UPPER TRISHULI-1 HEP (216MW)

REVIEW NOTE

| Title of the Document | Excavation and Initial Support Drawings of Adit No. 3 | | |
| Review Note No. | RN-0054 | Present Review Date | 04.02.2022 |

Drawing UT1-C-150-CVL-DG-43004-04, Rev. 0

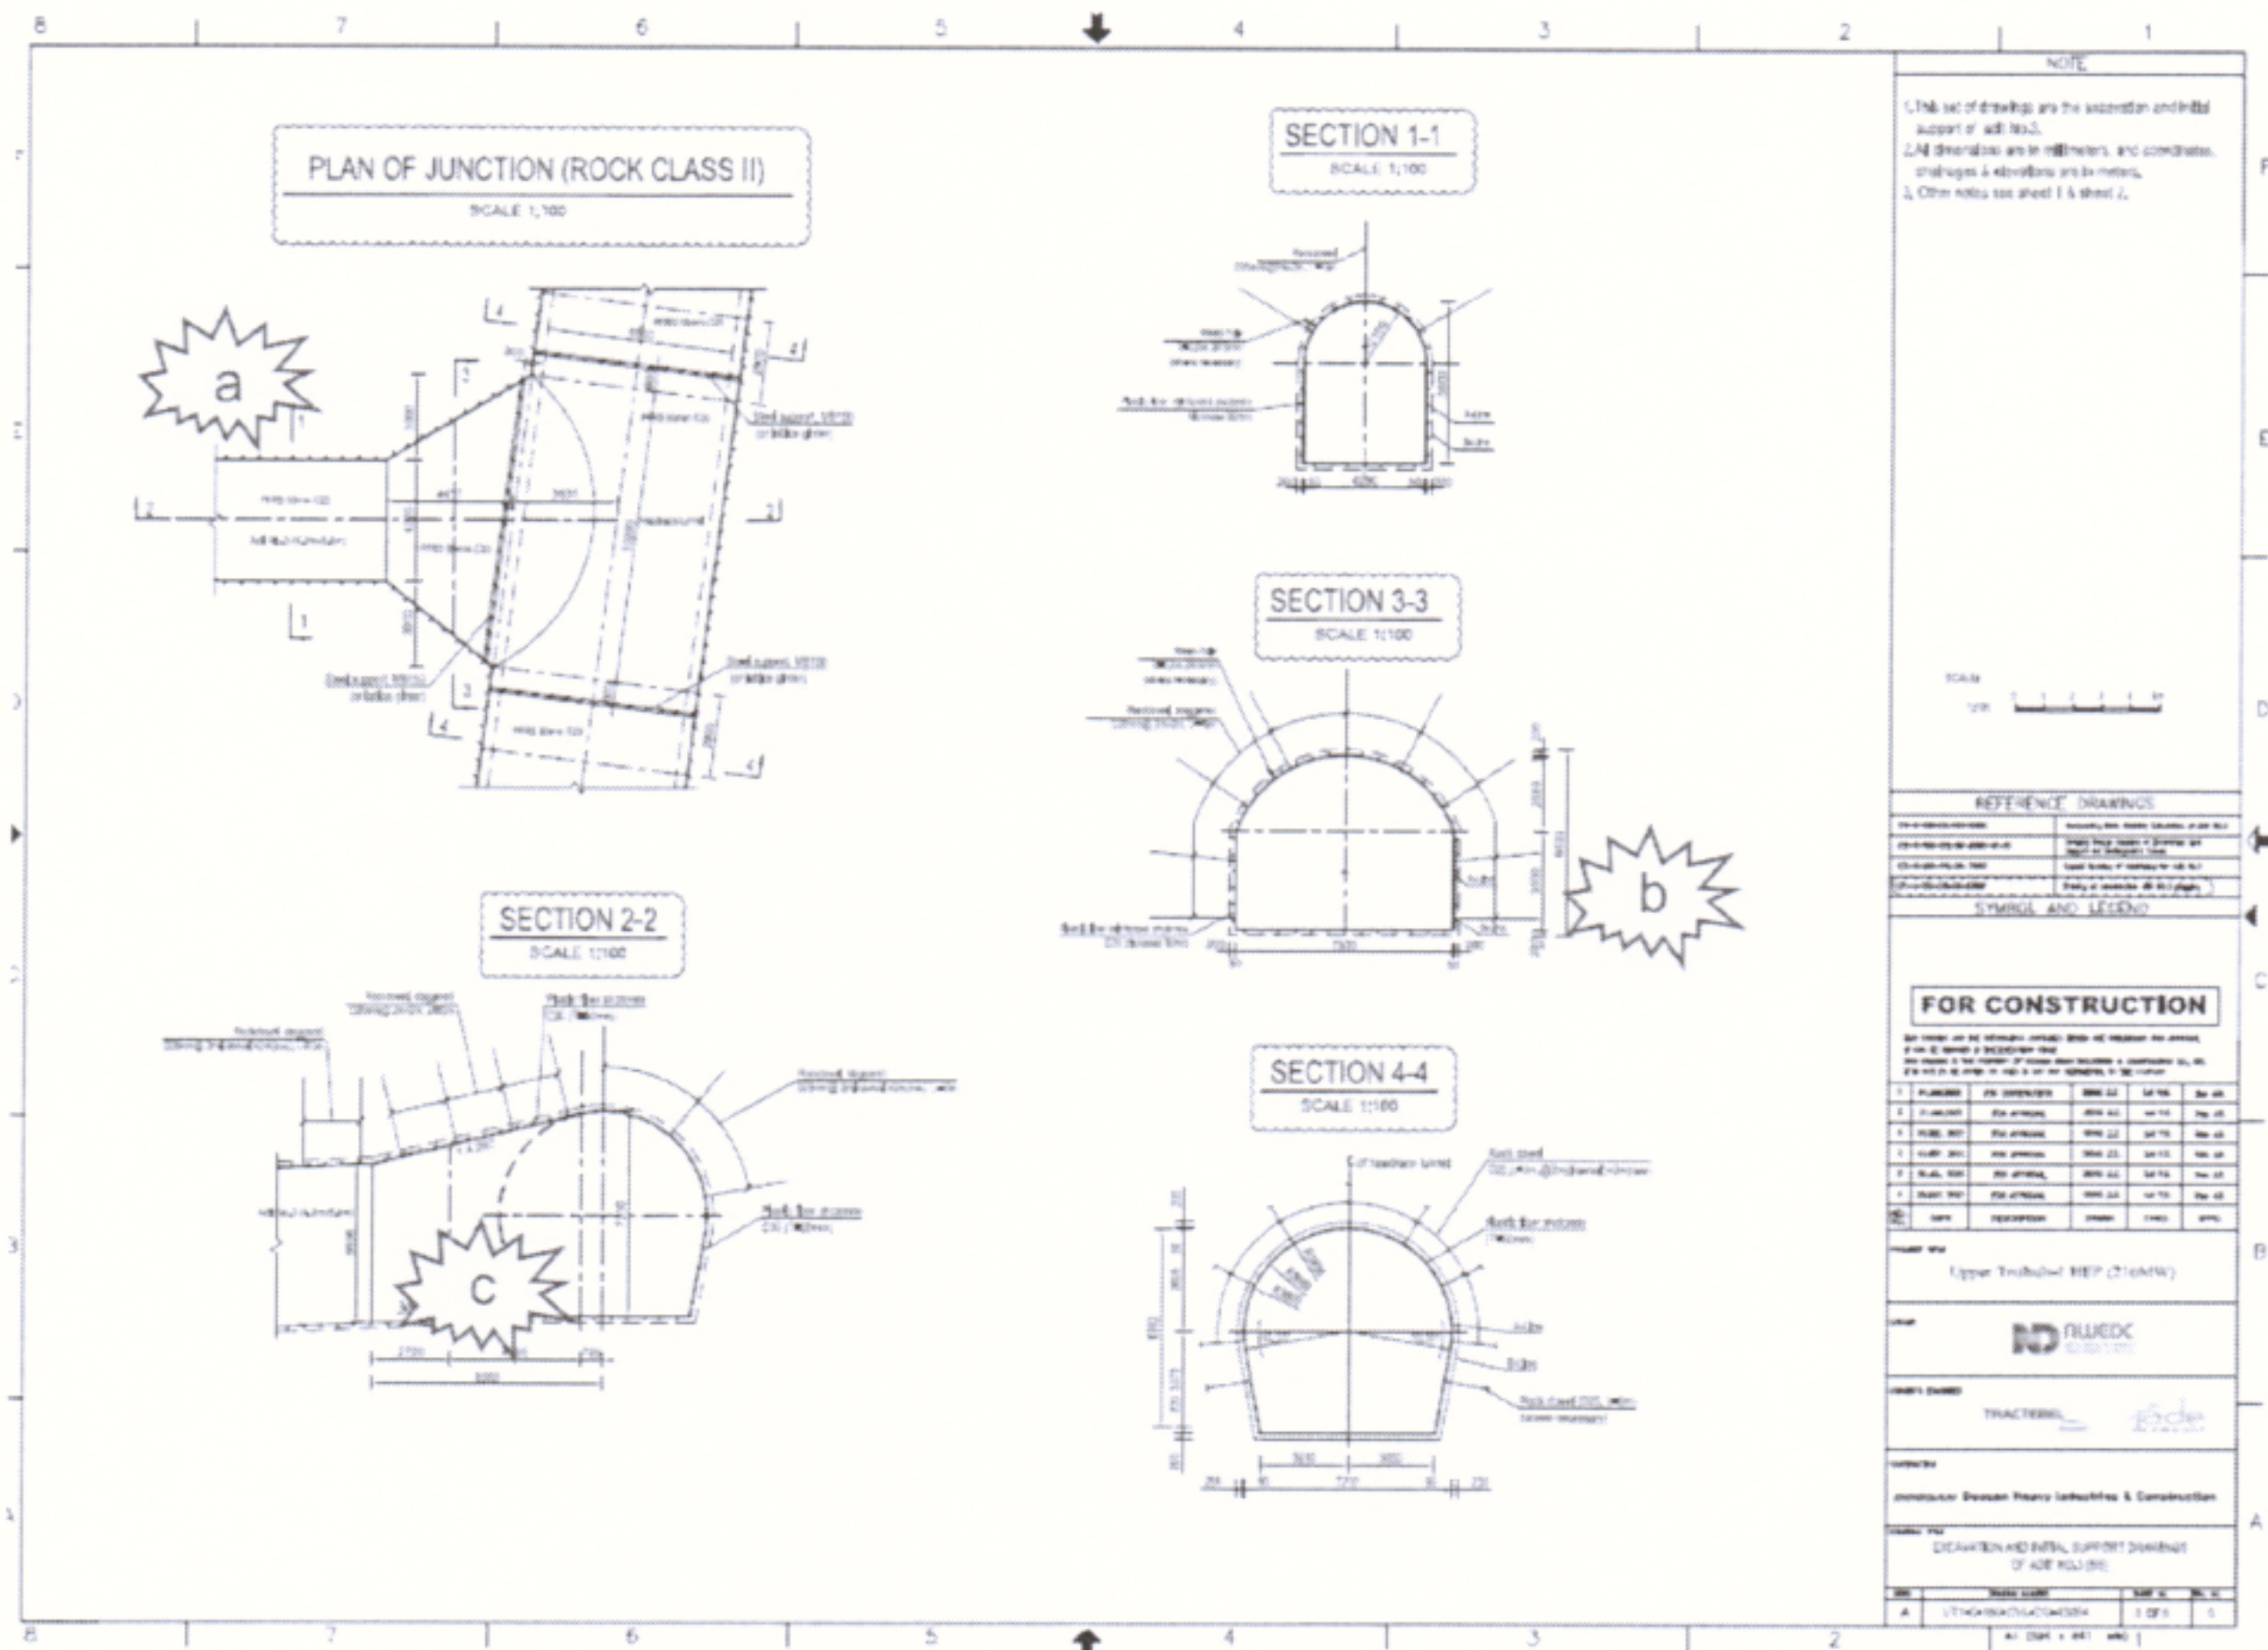
- a) No weepholes in Class I. Omit.
- b) In Class IV there should be no change of shotcrete type from C25 to C30. Use C25 and thickness of 150 mm, applied in two layers of 75 mm.
- c) Dowels in sidewalls need to be spaced narrower to take moments from steel rib.
